=====
PennDOT BQAD Publications e-Notification
Bureau of Design
Bridge Quality Assurance Division
=====

Publication No. 218M & 219M
Standard: All Current
RE: Linked PDF files
No. 14
Date: 1-29-07 w/ 11-28-07, 4-24-13 & 12-30-13 updates

PennDOT e-Notification No. 30

Interim Revision to Bridge Standard Drawing(s)	BD-601M, "Concrete Deck Slab", Sheet 4, dated 9/20/2010. Sidewalk Cross slope and reinforcement revisions.
--	--

ALTERNATIVE CUTOFF WALL WITH GROUTED ROCK

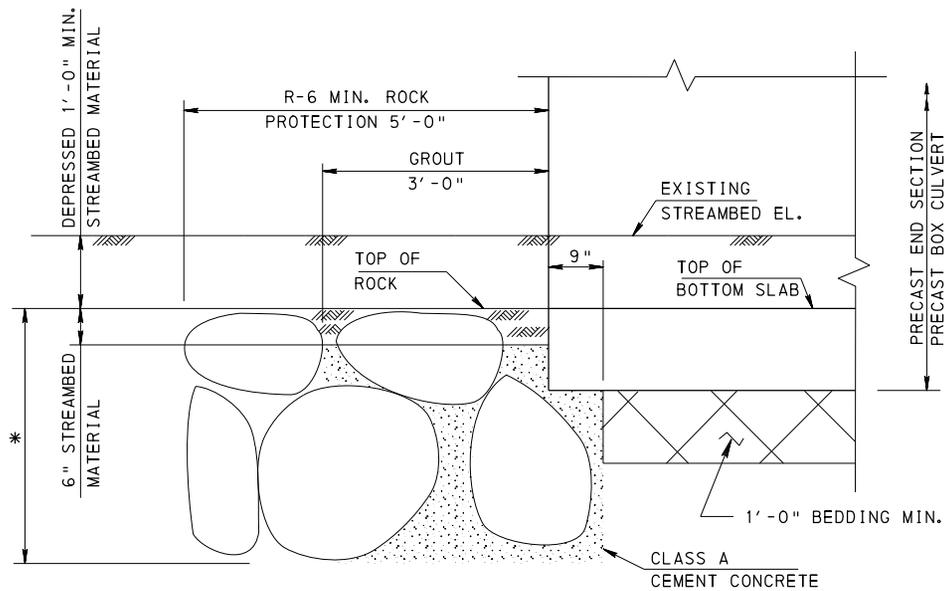
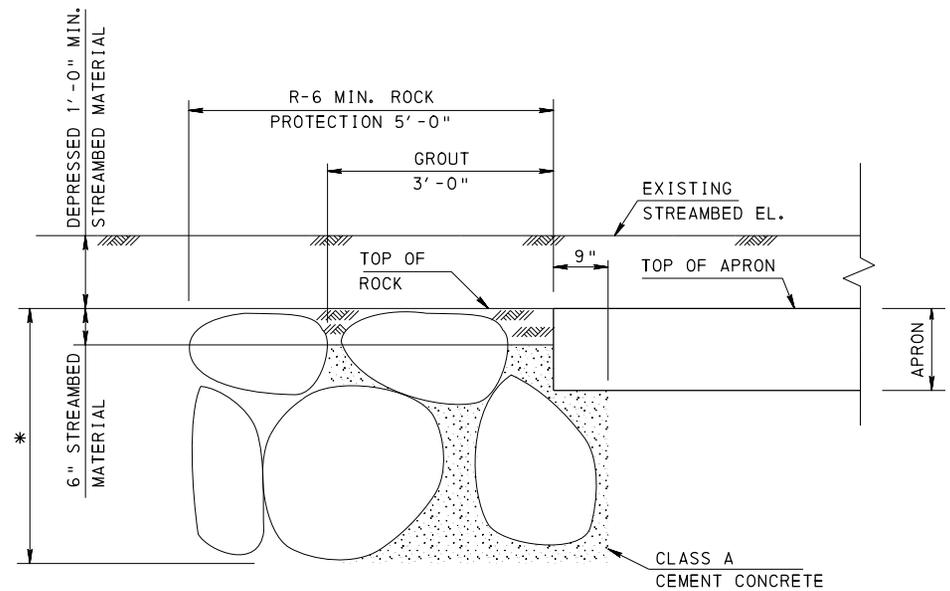
An alternative cutoff wall with grouted rock detail is being added to the box culvert standard.

* TO BOTTOM OF WINGWALL FOOTING OR BOTTOM OF ROCK LINING WHICH EVER IS DEEPER (3'-6" MIN.). FILL VOIDS IN ROCK WITH VIBRATED CLASS A CEMENT CONCRETE 6" BELOW STREAMBED TO BOTTOM OF ROCK. FILL TOP 6" OF ROCK WITH NATURAL STREAMBED MATERIAL

ELEVATION & VIEW A-A

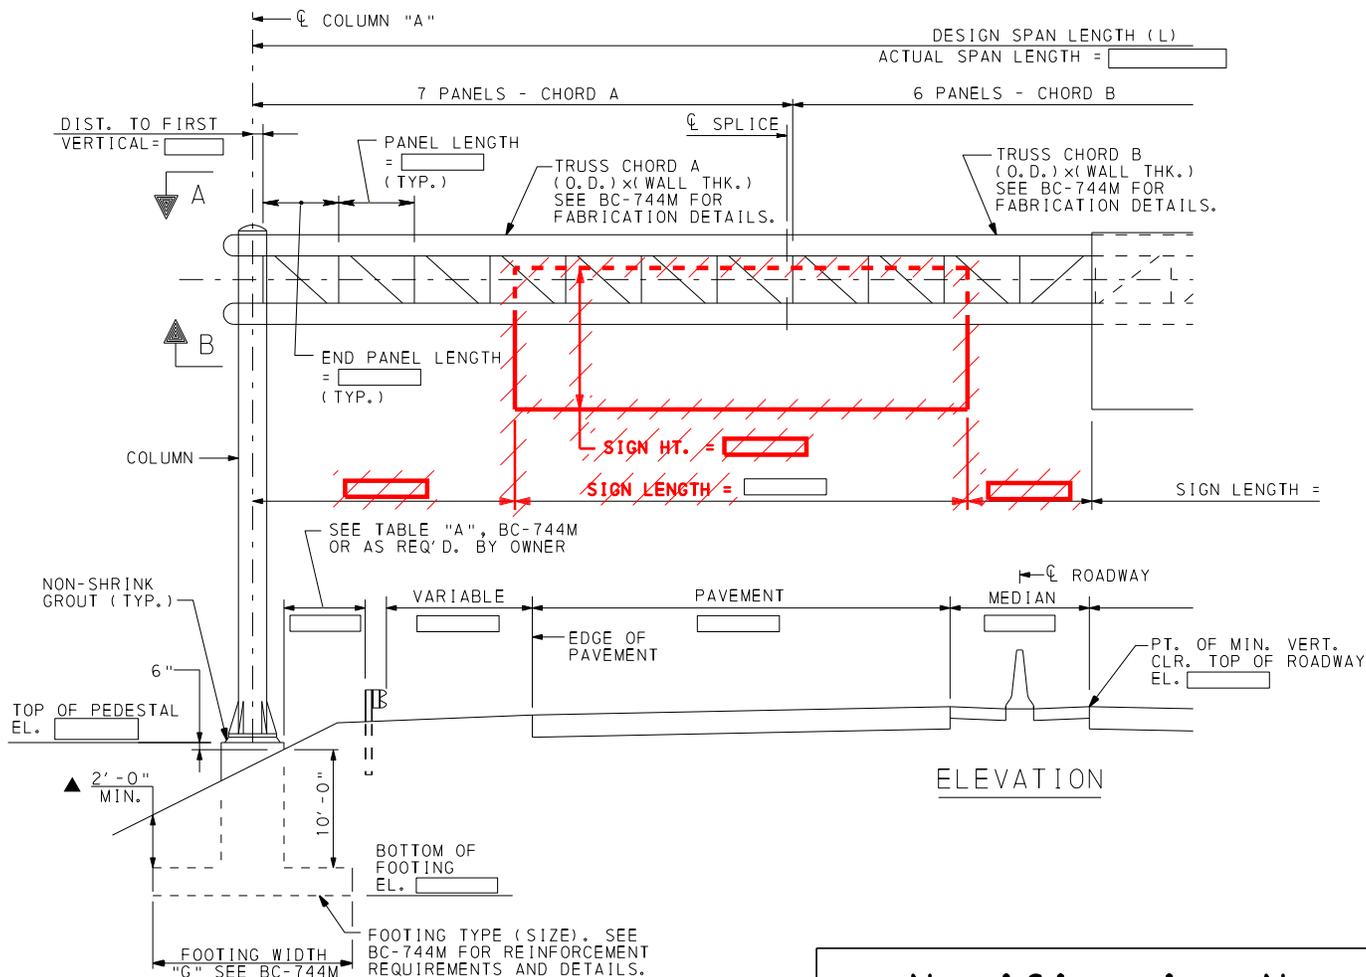
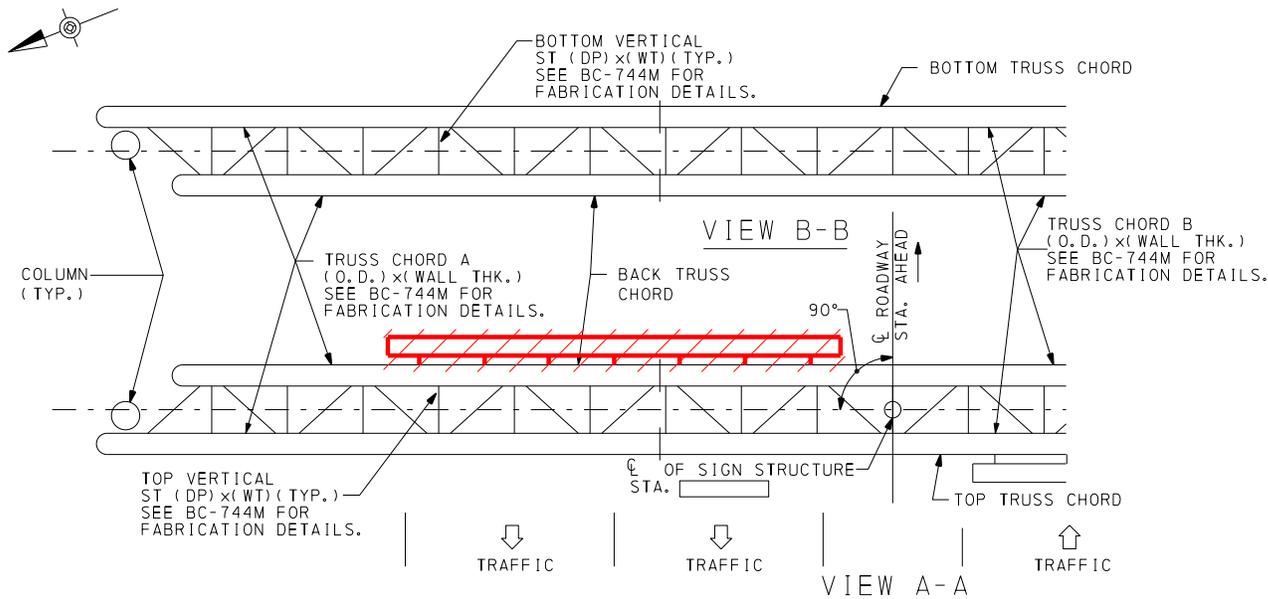
To be in accordance with the above mentioned restriction, the back side sign panel is being removed from BD-644M, Sheet 4 as indicated on the attached page.

e-Notification No. 43
(BD-632M, Sht. 8)

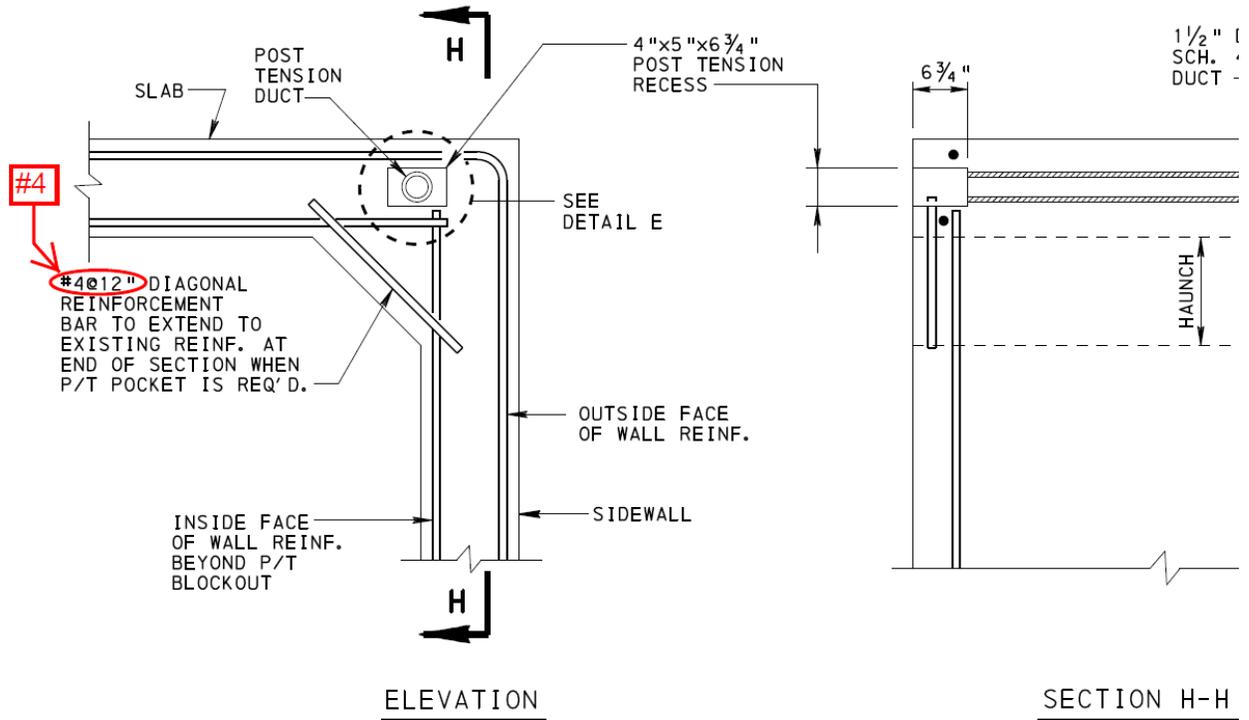
ELEVATION: remove the spacing in the callout for the diagonal reinforcement bar placed in the haunch since only a single bar is required at the end of the box culvert when a post-tensioning pocket is present. See the markup of this detail on the next page.

e-Notification No. 44
(BD-661M, Sht. 2)

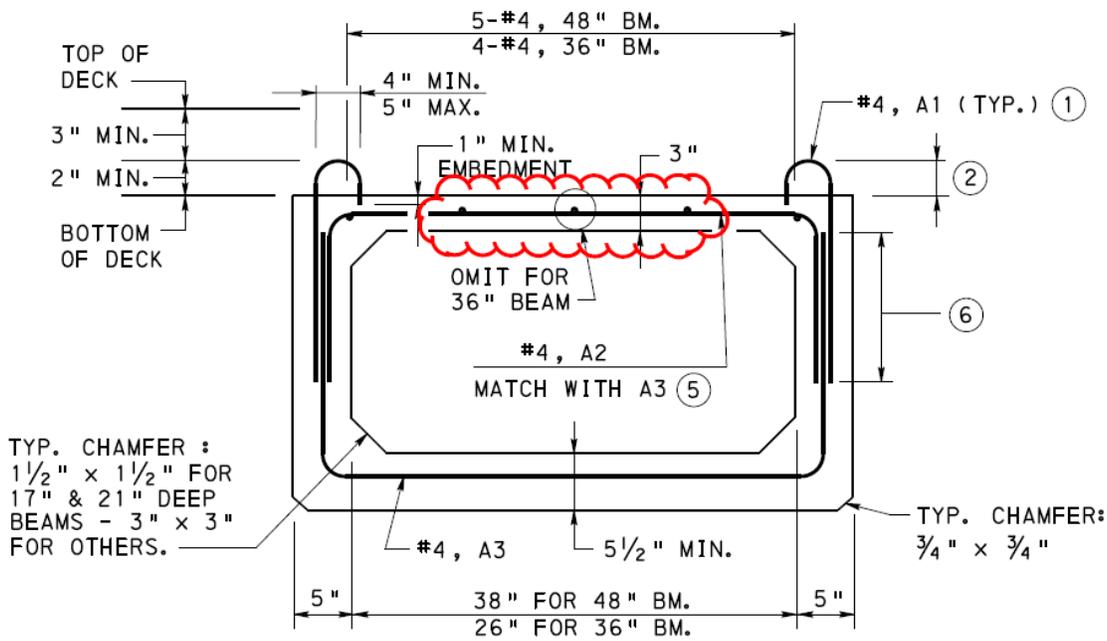
TYPICAL SECTIONS: Top slab longitudinal rebar in adjacent box beams to be repositioned to be on the top of the transverse beam reinforcement. See the four typical sections with this correction clouded in red on the next three pages.

SECTION A-A

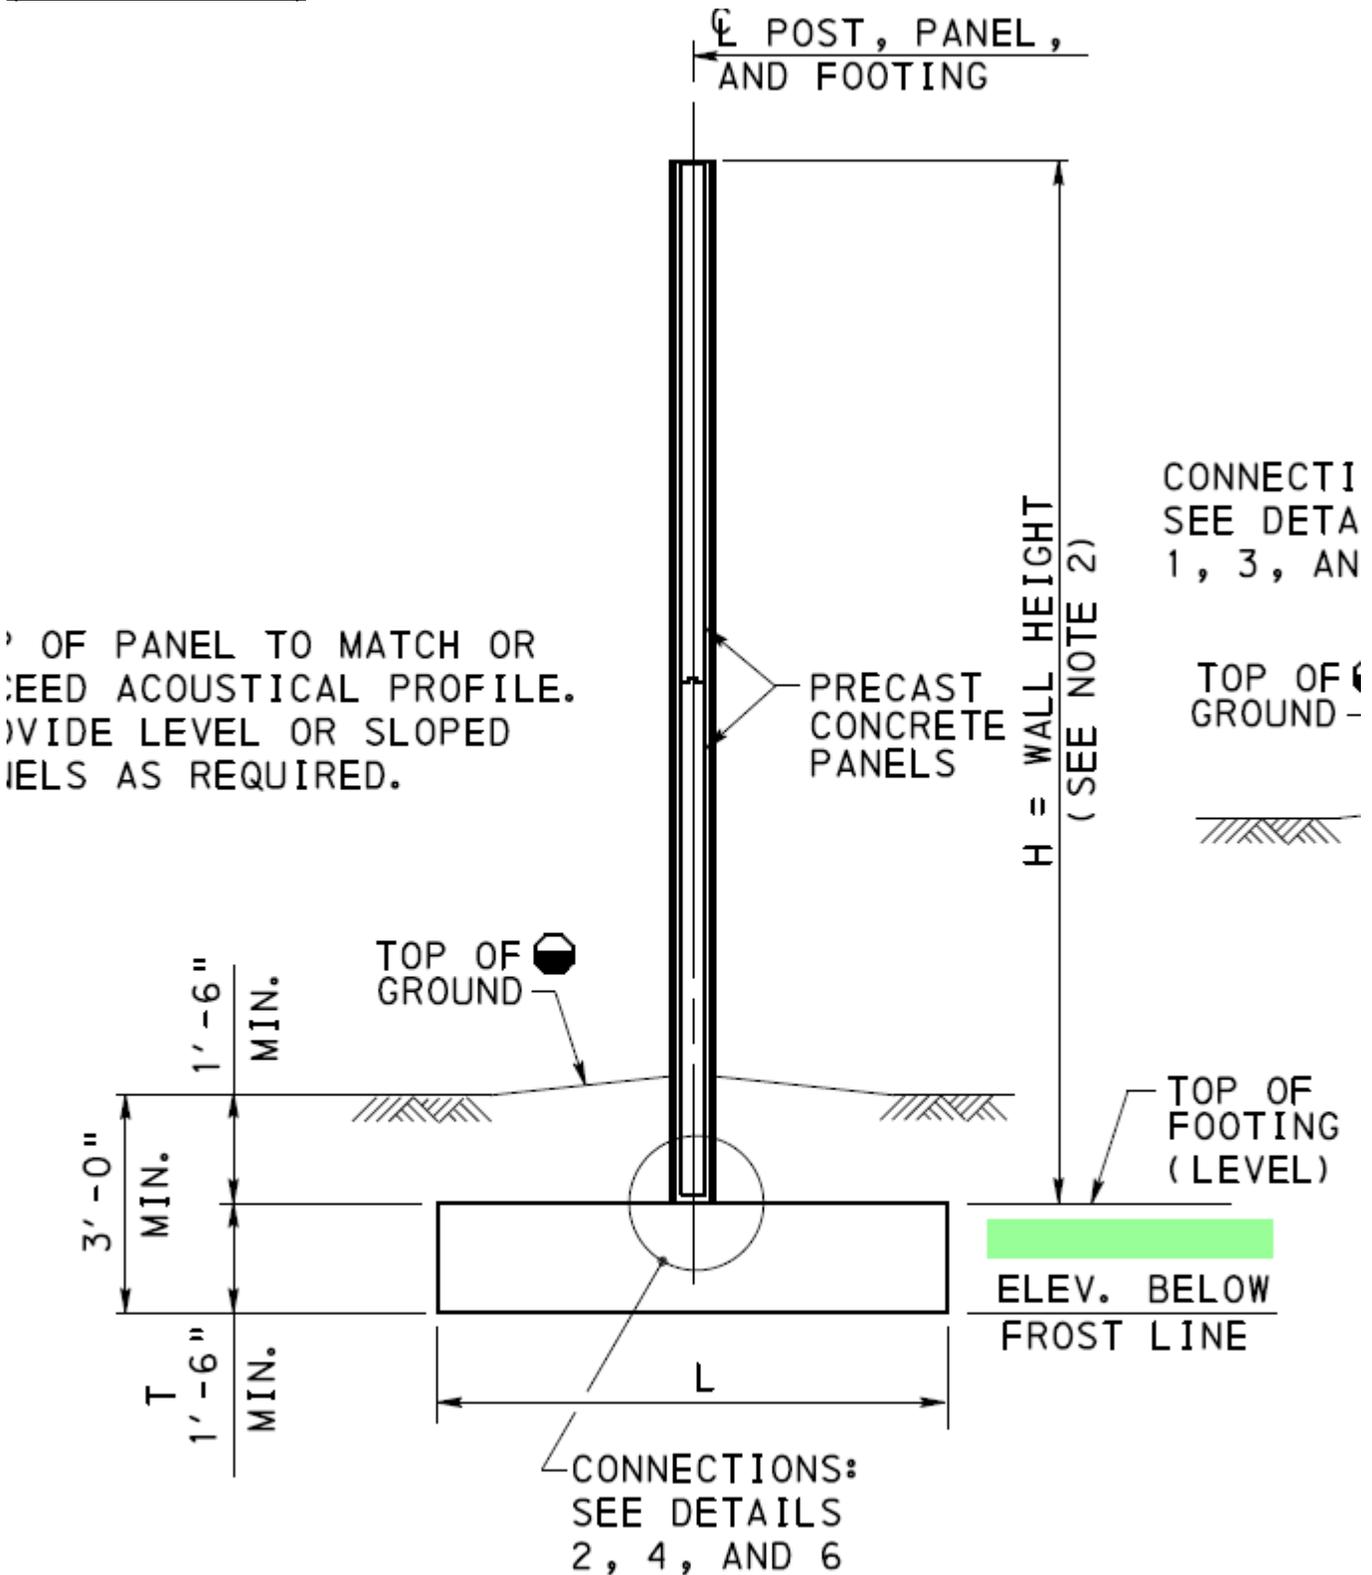
BACKGROUND: One of the Districts reported being confused over the minimum footing depth. After extensive review, it was decided to remove the Design Parameter note regarding the minimum design footing depth.

SECTION A-A: An extraneous horizontal line segment was removed to the right side of the footing. See the revised Design Parameters Notes for Spread Footings and Section A-A on the next two pages.

e-Notification No. 46 – BD-649M, Sheet 3:

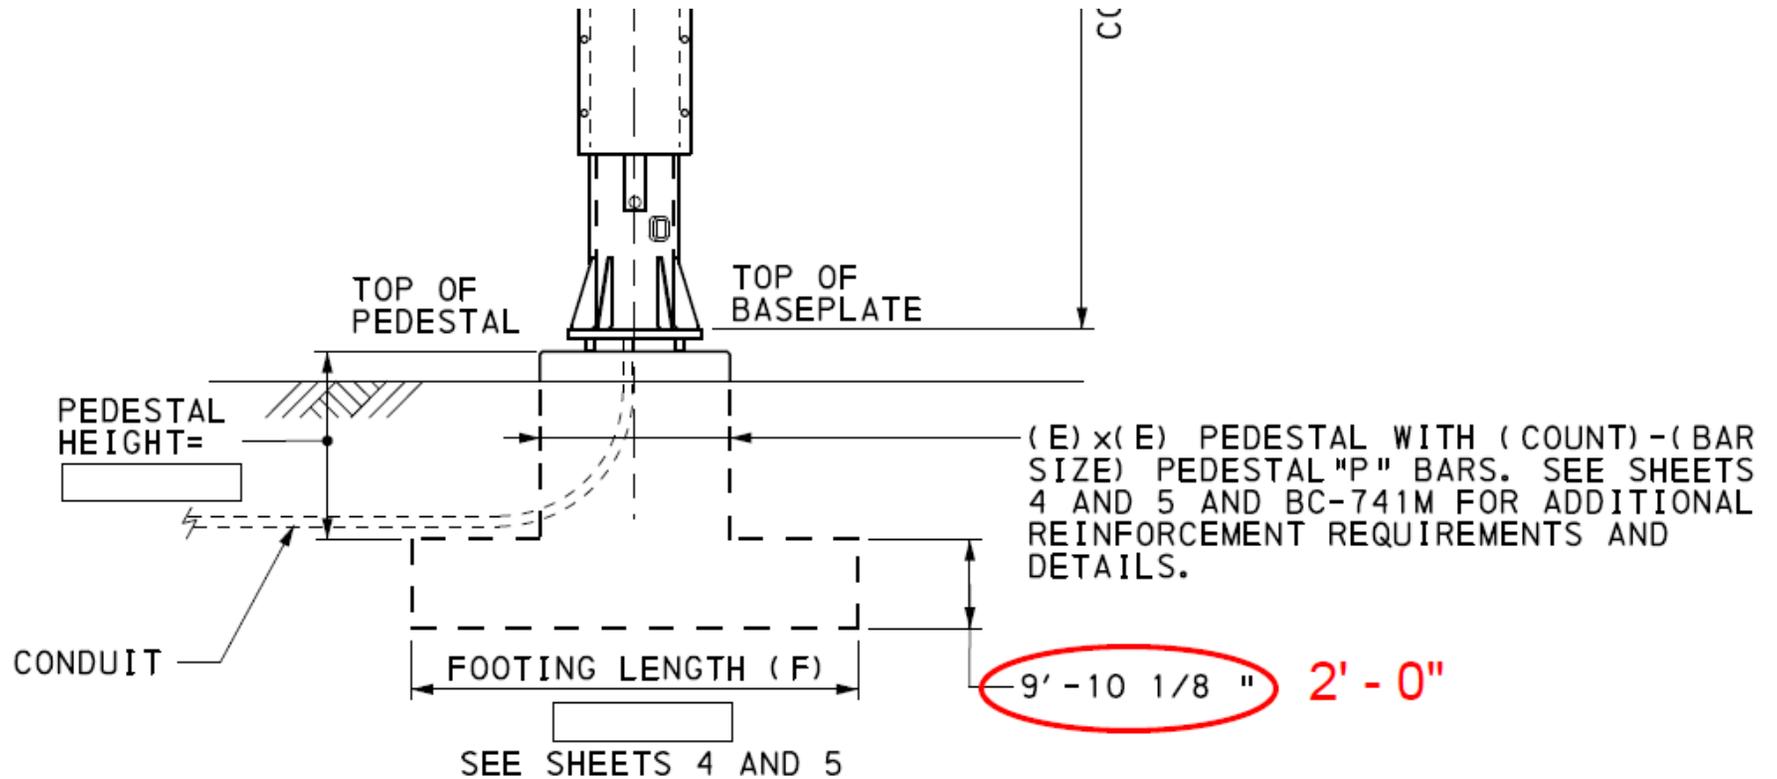
Sheet 3, SIDE ELEVATION: replace erroneous footing thickness with 2'-0".

Sheet 4, TABLE 1, PEDESTAL SIZE (E): revise two entries to be 4'-3" and 3'-9".

e-Notification No. 47
(BD-661M, Sht. 2):

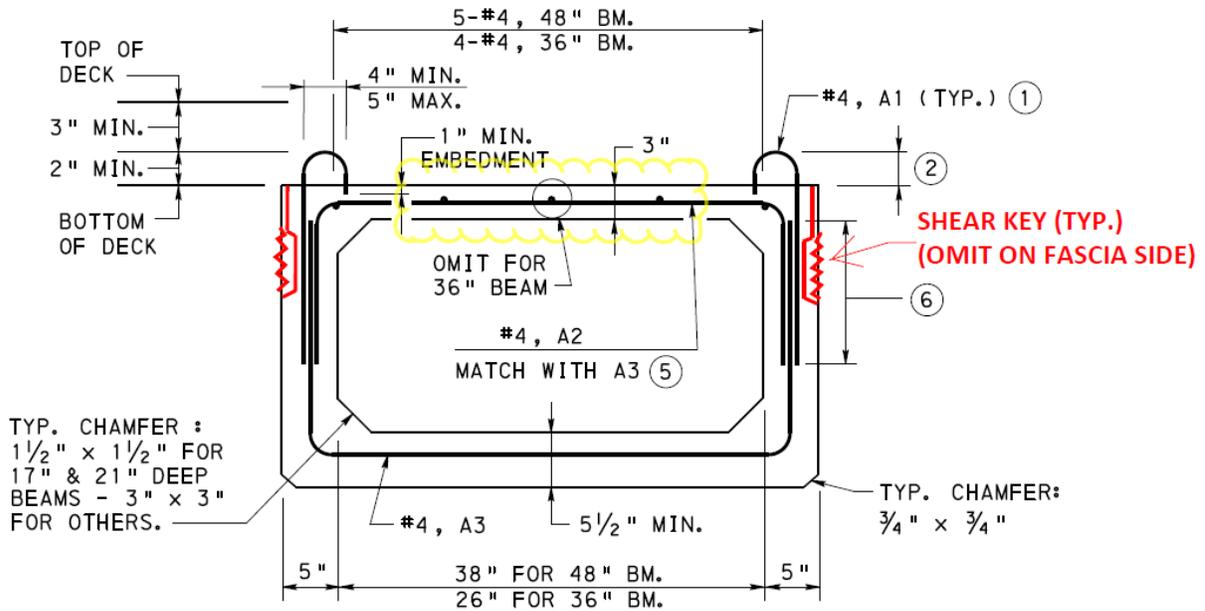
Sheet 2, ADJACENT BOX BEAM SECTIONS: added missing lines for shear keys on both sides of the box. Also, added a call-out for shear keys on one side of box.

BD-627M, Sht. 5,] **MOMENT SLAB (BURIED) WITH TOE WALL**
AND TYPICAL C.I.P. BARRIER
 dated 8-31-2012

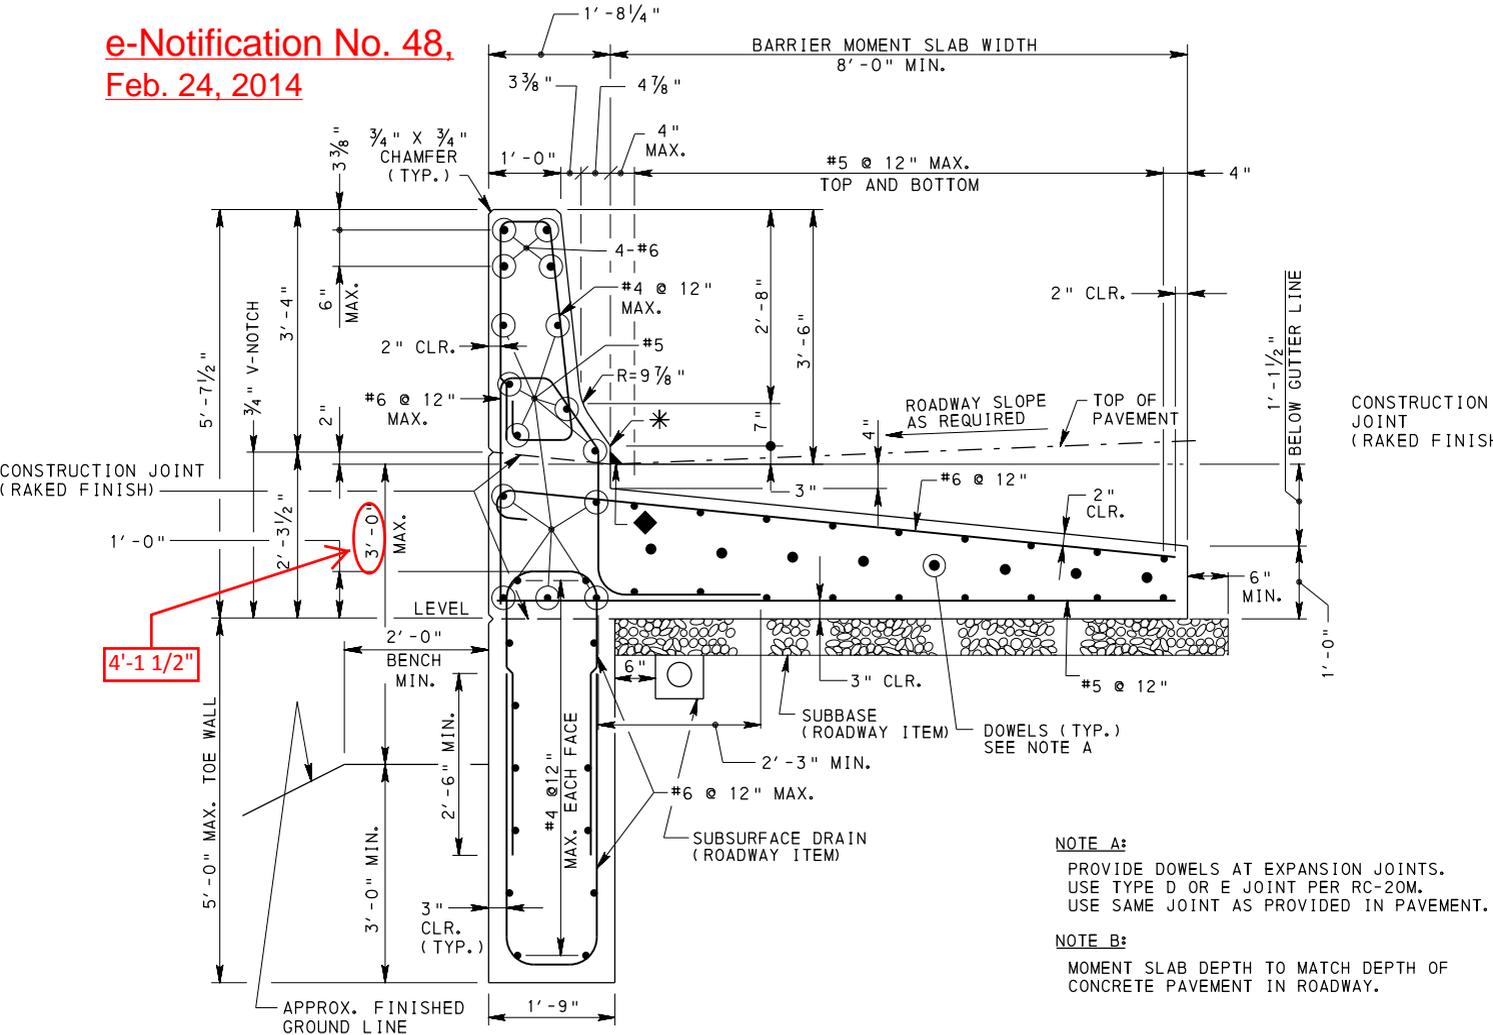
DETAIL - MOMENT SLAB (BURIED) WITH TOE WALL AND TYPICAL C.I.P. BARRIER: Revise **3'-0" MAX.** dimension for height of exposed front face of toe wall up to the gutter line to be **4'- 1 ½" MAX.**
